2010 Regulatory Correspondence between the NMED HWB and the Air Force regarding the Kirtland AFB, BFF Spill

**April 2, 2010 Correspondence from the NMED HWB
to Colonel Michael S. Duvall, Base Commander, 377 ABW/CC
Re: SWMUs ST-106 and SS-111, BFF Spill, Kirtland, AFB**

**RE: BULK FUELS FACILITY SPILL, SWMUS ST-106 AND SS-111
DIRECTIVE FOR CONDUCTING INTERIM MEASURES AND NOTICE OF
DISAPPROVAL
INTERIM MEASURES WORK PLAN, JUNE 2010;
VADOSE ZONE WORK PLAN, JUNE 2010;
GROUNDWATER INVESTIGATION WORK PLAN, JUNE 2010
KIRTLAND AIR FORCE BASE, EPA ID# NM9570024423
HWB-KAFB-10-015, HWB-KAFB-10-016, HWB-KAFB-10-019**

Figure 1. Soil Boring and Soil-Vapor Monitoring Well Locations

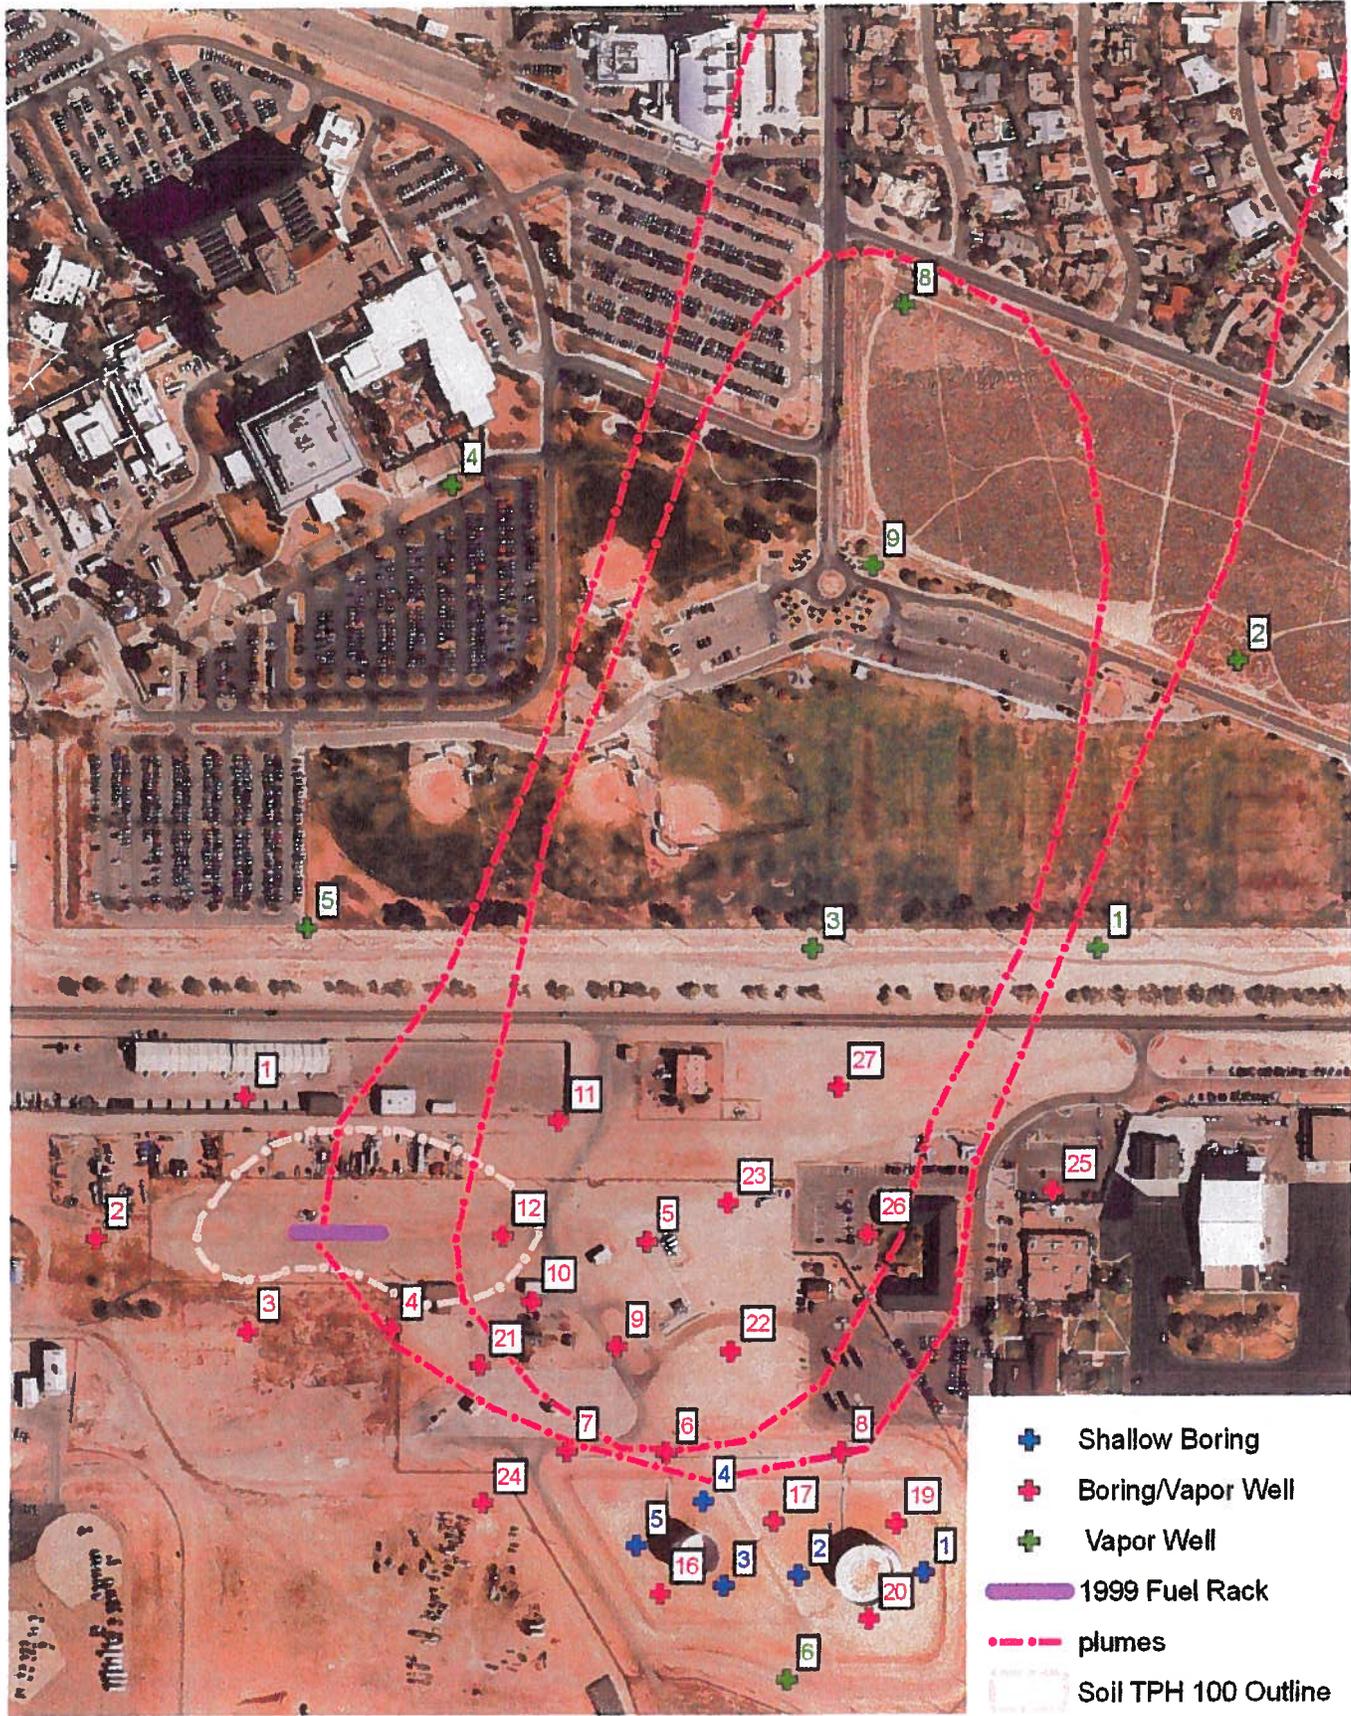
The Permittee shall complete the soil borings/soil-vapor wells at locations #16, 17, 19 and 20; and the soil vapor well at location #6 that are listed in Tables 1 and 2 of this letter, respectively, and shown on Figure 1 enclosed with this letter. The Permittee shall also complete shallow soil borings to a depth of at least 20 feet at locations #1 through 5, which are listed in Table 3 of this letter and shown also on Figure 1. Soil samples from the shallow borings shall be collected at depths of 0, 5, 10, 15, and 20 feet and shall be analyzed for TPH, VOCs, SVOCs, and lead.

The Permittee shall complete the deep soil borings/soil-vapor wells at locations #4, 6, 7, 8, and 24 that are listed in Table 1 of this letter and shown on Figure 1. The Permittee shall also complete shallow borings along the entire length of the pipeline between the tank farm and the Fuel Offloading Rack, regardless of whether the pipeline runs underground or on the surface. The borings shall be spaced at intervals not to exceed 25 feet and are to be located on both sides of the pipeline. Soil samples from the shallow borings shall be collected at depths of 0, 5, 10, 15, and 20 feet. The soil samples from deep and shallow borings shall be analyzed for TPH, VOCs, SVOCs, and lead. Depending on the results, NMED may require further investigation of this area, including more and deeper borings.

The Permittee did, however, propose an additional 3 deep soil sampling/vapor wells at locations further to the east. NMED agrees that these latter locations are necessary to properly characterize this area. Thus, to improve the understanding of the amount of fuel contamination in the vadose zone that must be remediated, the Permittee shall complete the soil borings/soil-vapor wells at locations #5, 9, 10, 21, 22, 23, 25, 26, and 27 listed in Table 1 and shown on Figure 1.

5. Far field area of Soil-Vapor plume – In its letter of April 2, 2010, NMED directed the Permittee to install six soil-vapor wells at locations north of the Fuel Offloading Rack and fuel percolation area to investigate the concentrations of hazardous constituents in soil gas that overlies groundwater in these areas. The Permittee shall complete the soil-vapor wells at locations #1, 2, 4, 3, 5, 6, 8, and 9; and the soil boring/soil-vapor well at location #24, that are listed in Tables 2 and 1, respectively, and shown on Figure 1.

The coordinates in Tables 1-3 are State Plane Coordinates in feet, NAD83. All boring/soil vapor well locations are also shown on Figure 1 enclosed with this letter.

Figure 2. Groundwater Monitoring Well Locations

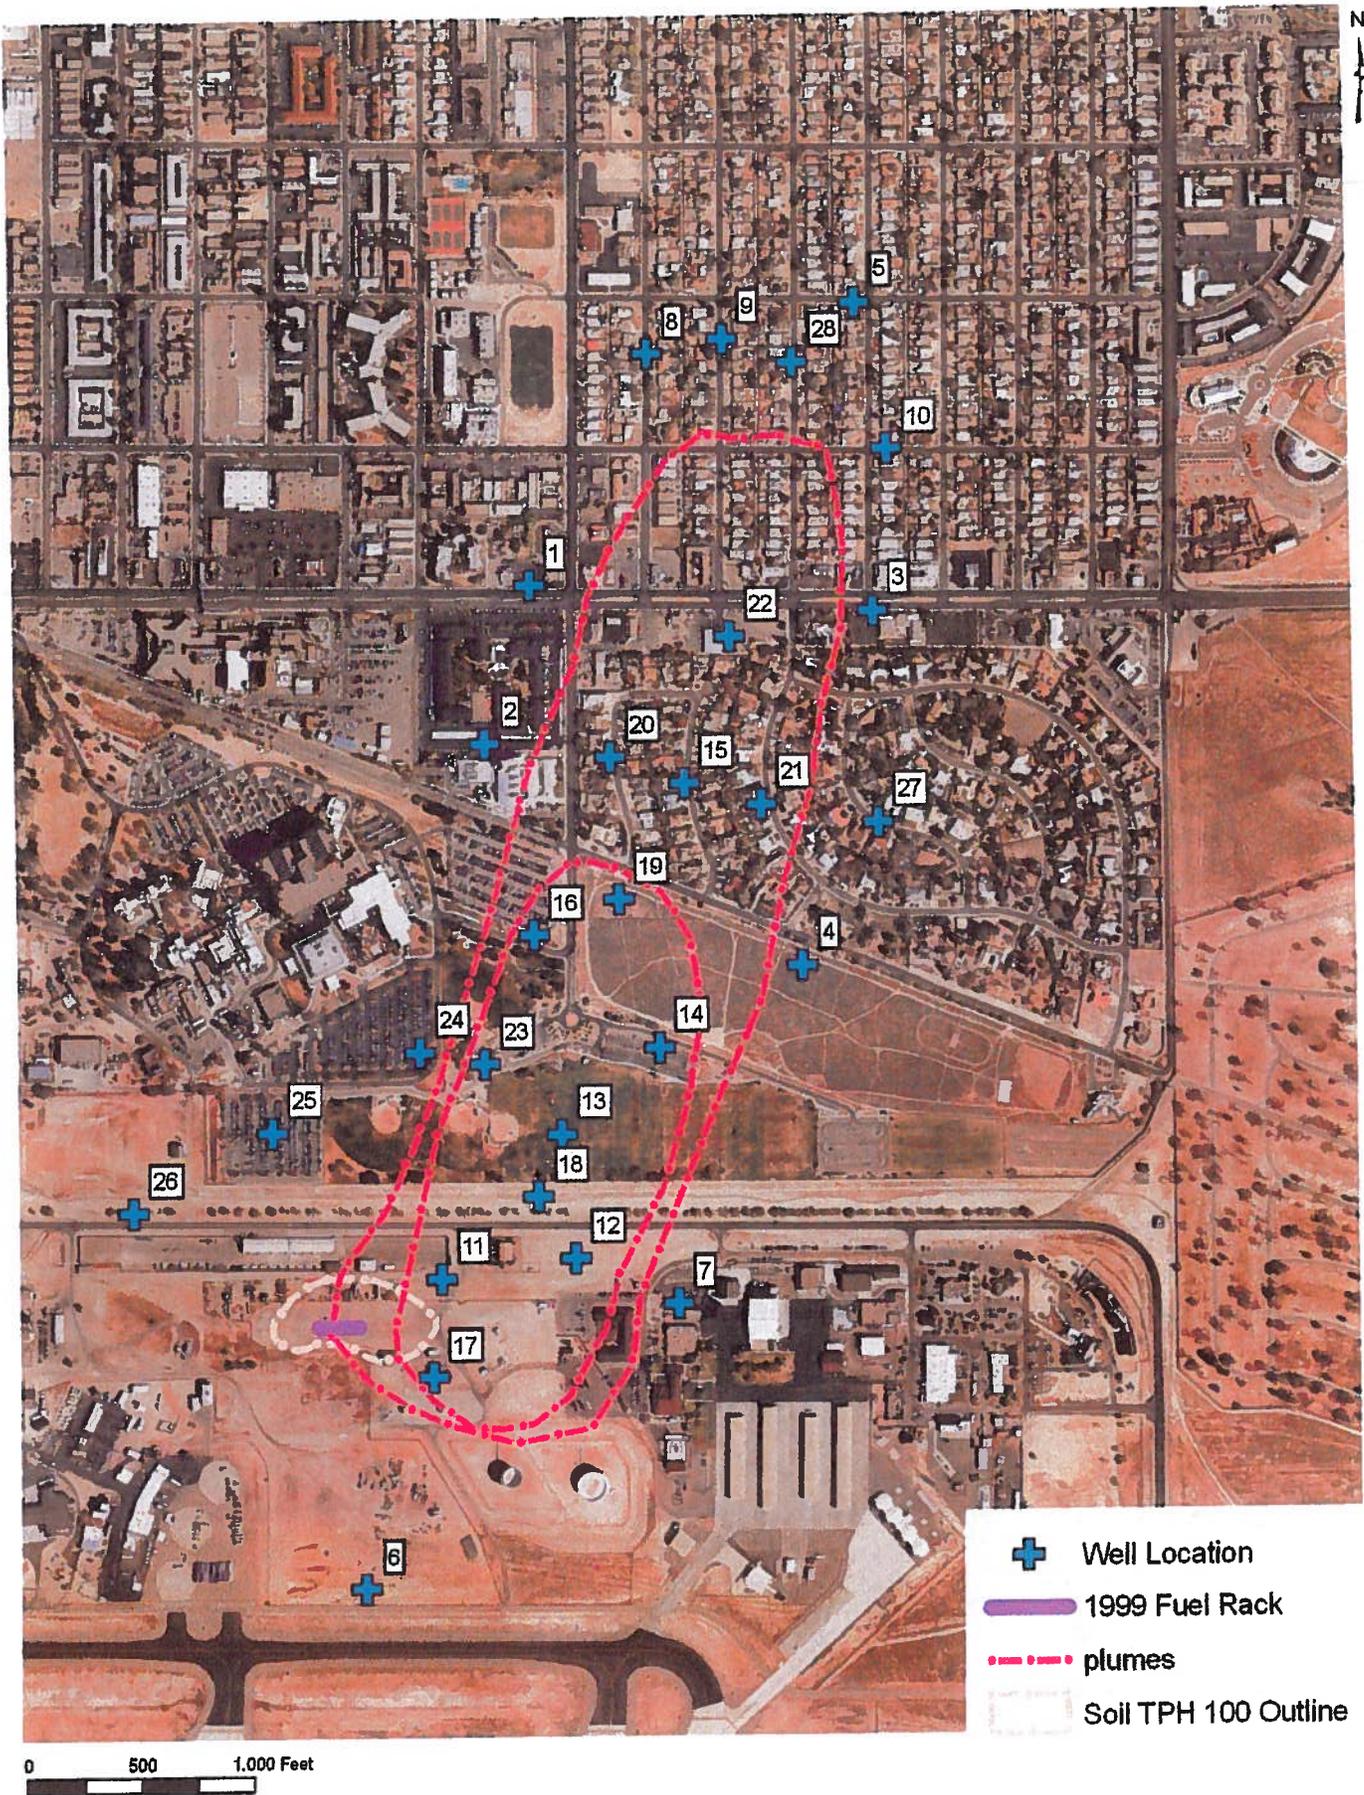
1. Background Water Quality - Only two upgradient wells have been installed that potentially may yield groundwater samples that are free from contamination. Both of these wells were only recently completed; none is screened appreciably below the water table to provide vertical characterization of water quality, geology, and hydrologic conditions. The Permittee must complete the background cluster/nested wells at location #6 listed in Table 4 of this letter and shown on Figure 2 (enclosed).

To achieve the objective of providing initial plume-core characterization, the Permittee shall install the groundwater monitoring wells at locations #11, 12, 13, 14, 15, 16, 17, 18, 19, 20, 21, 22, and 23 listed in Table 4 and shown on Figure 2.

To adequately provide initial plume-edge characterization, the Permittee shall install the groundwater monitoring wells at locations #1, 2, 3, 4, 5, 7, 8, 9, 10, 24, 25, 26, 27, and 28 that are listed in Table 4 and shown on Figure 2.

Coordinates in Table 4 are State Plane Coordinates in feet, NAD83. All of the locations listed in Table 4 are also shown on Figure 2 enclosed with this letter.

Figure 3 Existing Soil Boring, Soil-Vapor Monitoring Well and Cross-Section Locations

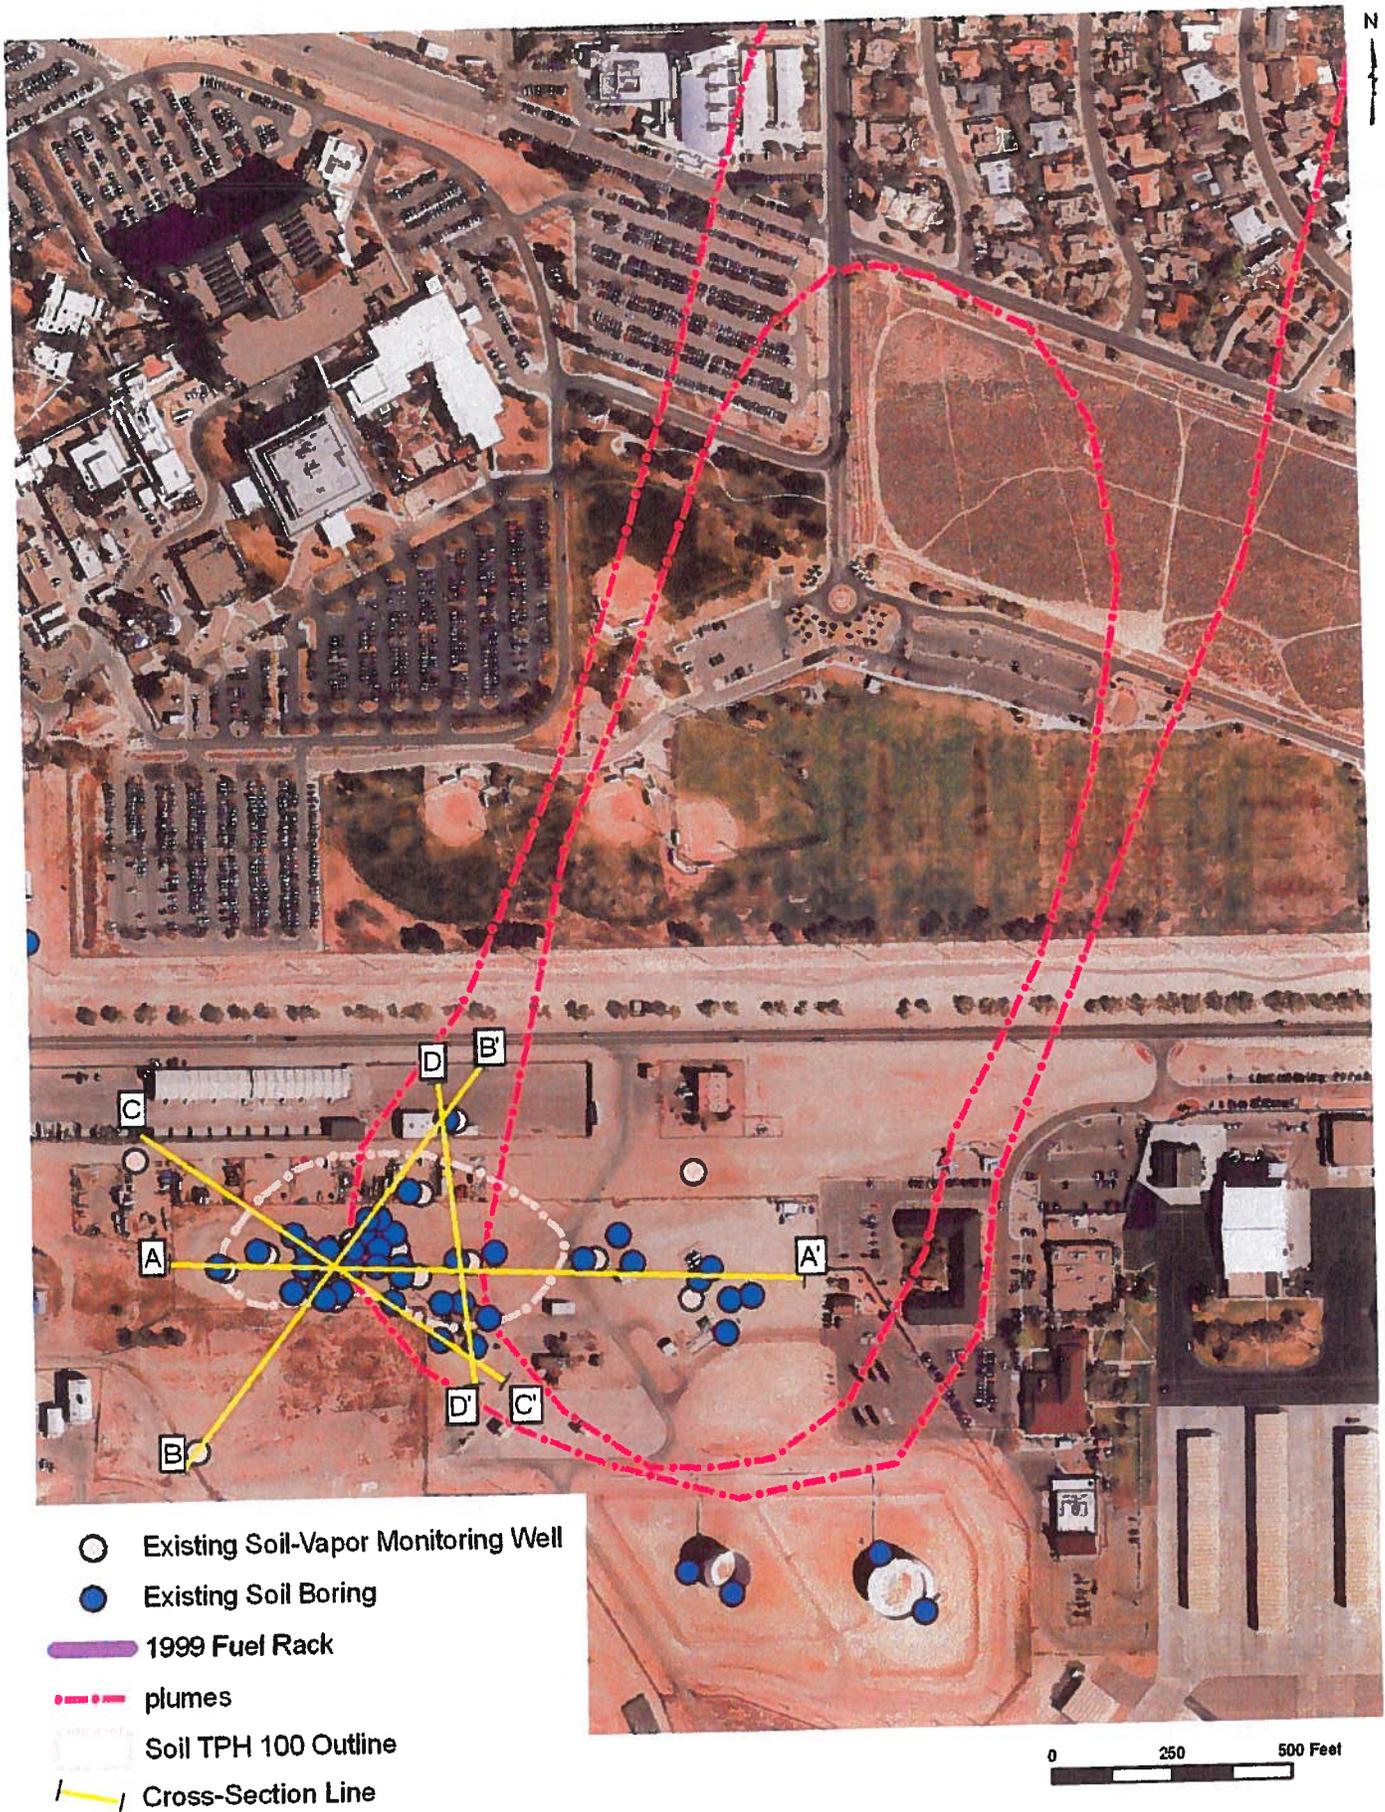
- v. Cross-sections showing the geology of the site drawn to a horizontal scale of 1 inch equals 50 feet, a vertical scale of 1 inch = 50 feet, and along the orientations A-A', B-B', C-C', and D-D' as shown on Figure 3 enclosed with this letter.

- vii. Cross-sections showing concentrations of major hazardous constituents in soil, drawn to a horizontal scale of 1 inch equals 50 feet, a vertical scale of 1 inch = 50 feet, and along the orientations A-A', B-B', C-C', and D-D' as shown on Figure 3 enclosed with this letter.

- viii. Cross-sections showing concentrations of major hazardous constituents in soil vapor, drawn to a horizontal scale of 1 inch equals 50 feet, a vertical scale of 1 inch = 50 feet, and along the orientations A-A', B-B', C-C', and D-D' as shown on Figure 3 enclosed with this letter.

Figure 4. Existing Well and Cross-Section Locations

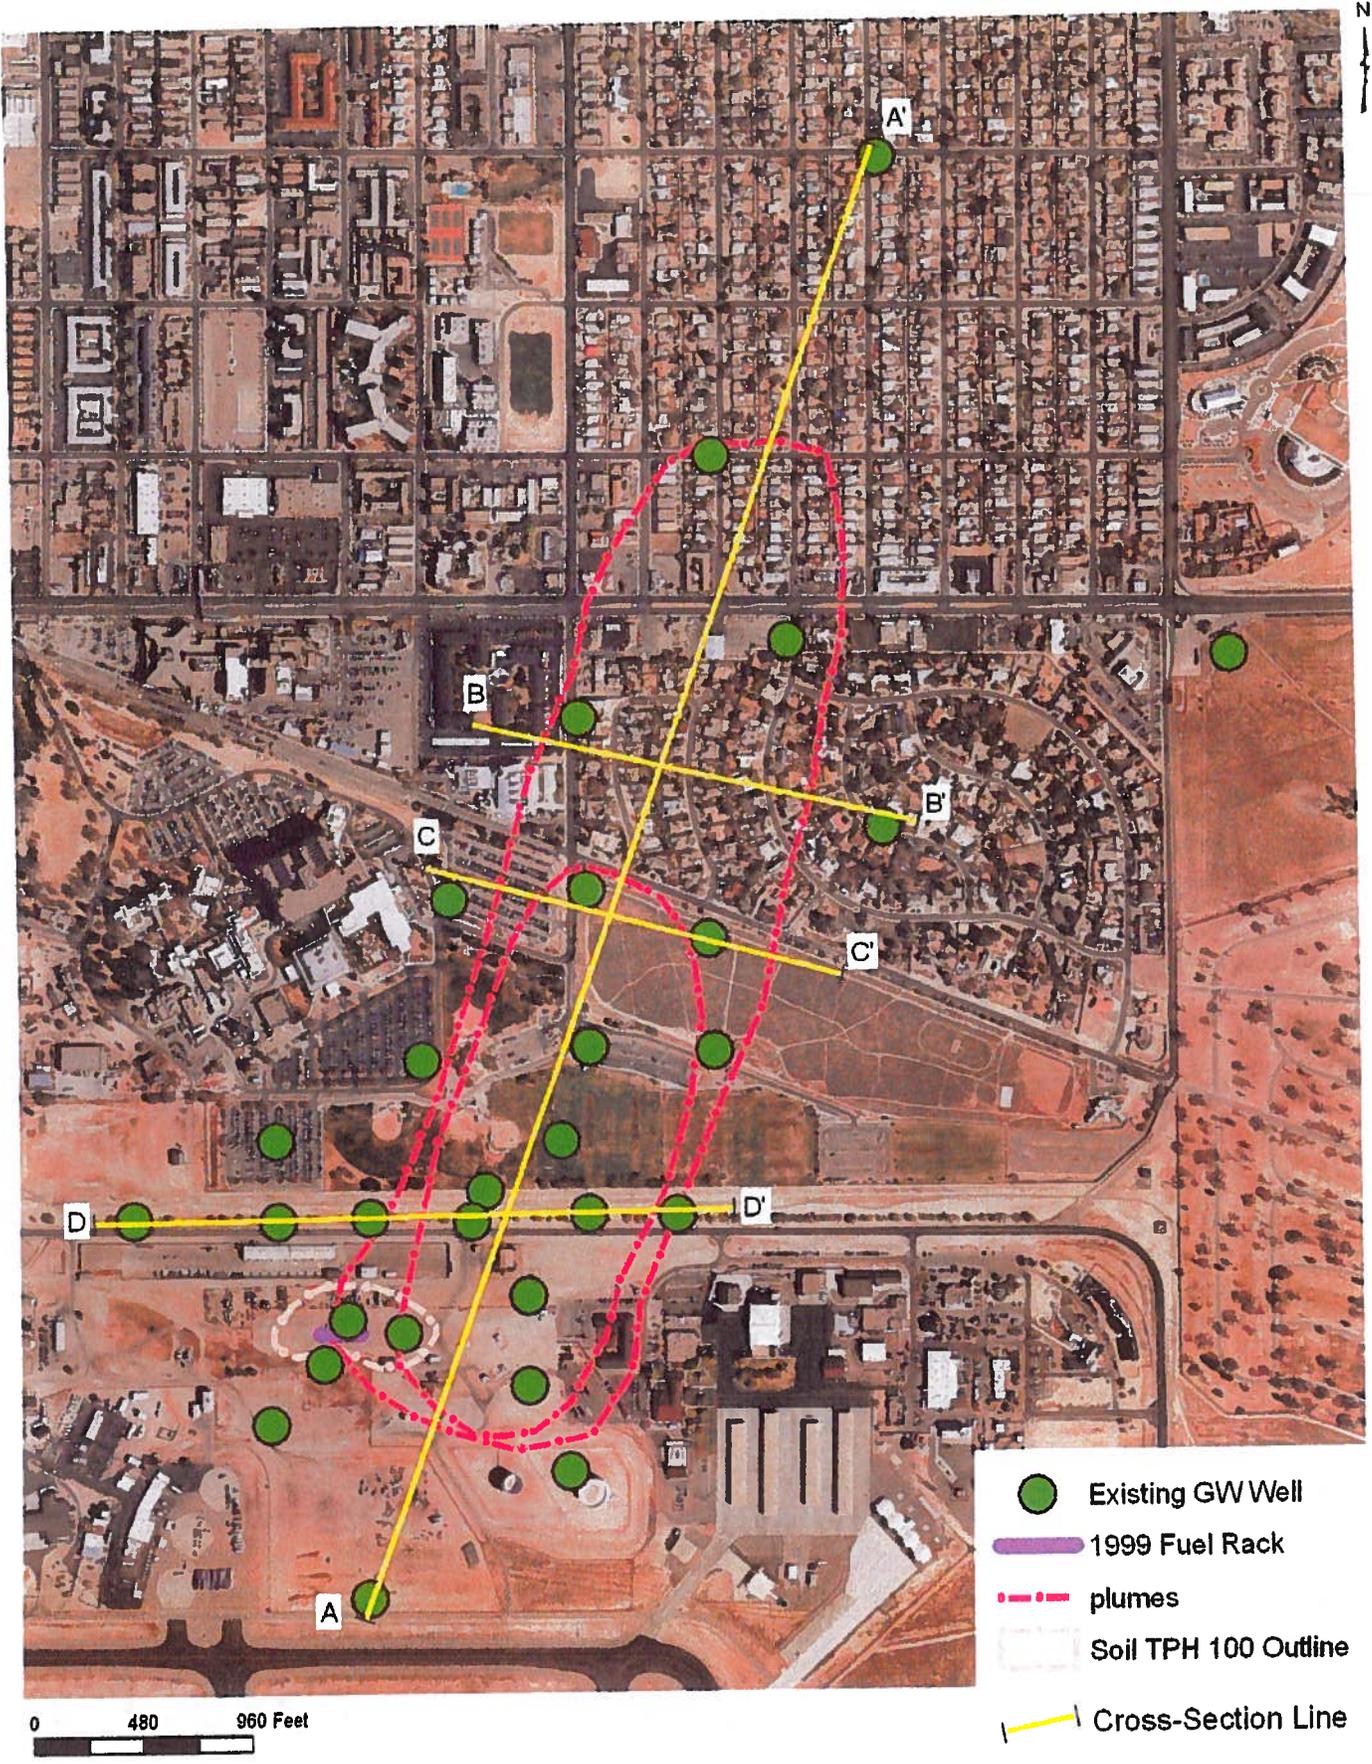
- vi. Cross-sections showing the geology of the site drawn to a horizontal scale of 1 inch equals 300 feet, a vertical scale of 1 inch = 50 feet, and along the orientations A-A', B-B', C-C', and D-D' as shown on Figure 4 enclosed with this letter.

- ix. Cross-sections showing concentrations of major hazardous constituents in groundwater, drawn to a horizontal scale of 1 inch equals 300 feet, a vertical scale of 1 inch = 50 feet, and along the orientations A-A', B-B', C-C', and D-D' as shown on Figure 4 enclosed with this letter.
